UNITED STATES PATENT AND TRADEMARK OFFICE

APPLICATION NO.	FILING DATE	FIRST NAMED INVENTOR	ATTORNEY DOCKET NO.	CONFIRMATION NO.
10/628,968	07/28/2003	Michael Thomas Krawczyk	Aqua Lung.1466	6187
27547	7590	11/01/2004	EXAMINER	
MURPHEY & MURPHEY, A.P.C. 701 PALOMAR AIRPORT ROAD, SUITE 260 CARLSBAD, CA 92009			MITCHELL, TEENA KAY	
			ART UNIT	PAPER NUMBER
			3743

Office Action Summary

DETAILED ACTION***Drawings***

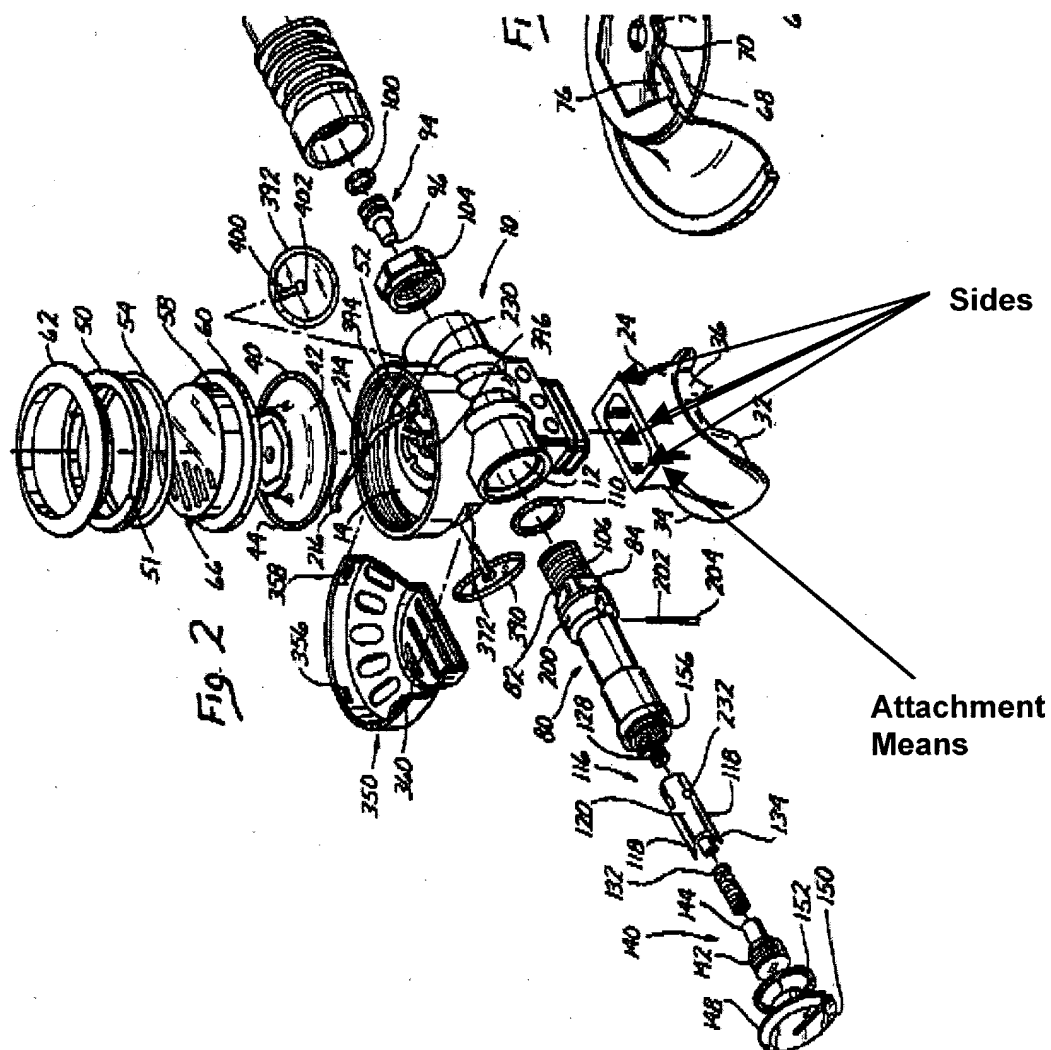
Claims 1-3, 5, 11, and 14 are rejected under 35 U.S.C. 102(b) as being anticipated by Winefordner et.al. (5,503,140).

Winefordner in a regulator discloses:

- a chamber having a cylindrical body (10);
- a first opening on the cylindrical body (14) wherein an exhaust valve (40) is removably attached to the first opening of the cylindrical body;
- a second opening on the cylindrical body (note #24; opening where 24 inserts into the body) wherein a mouthpiece (24) is removably attached to the second opening of the cylindrical body;
- a hose (at 104) connected to the chamber wherein the hose connects the cylindrical body to an air source.

With respect to claim 5, the mouthpiece has an attachment means with a plurality of sides for attachment to the regulator (see illustration of Fig. 2 below).
